ENHANCEMENT OF PRODUCT APPEAL

■ PARTS WITH LOW REPAIR COST

025BO23Y

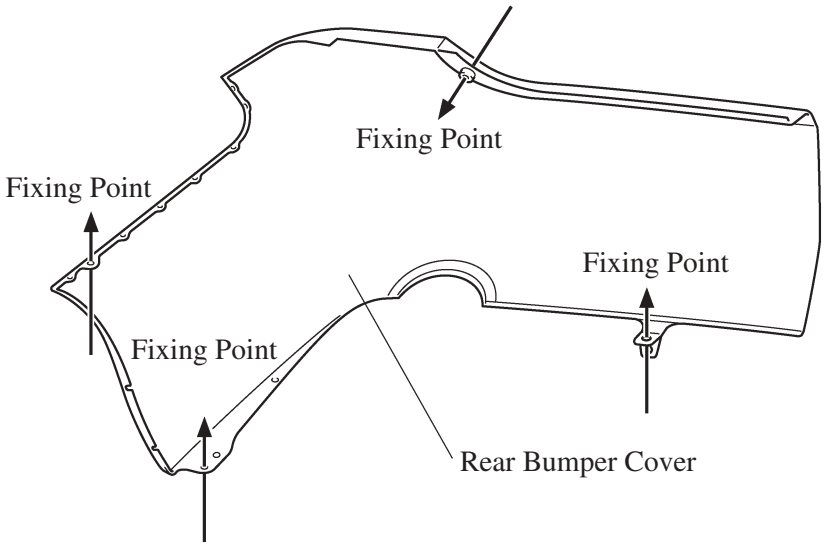
- The plating portion of the front grille of N, D, and G grade models for Australia and G.C.C. Countries, has been redesigned as an individual part. As a result, replacement of damaged parts only is possible, therefore reducing repair costs.
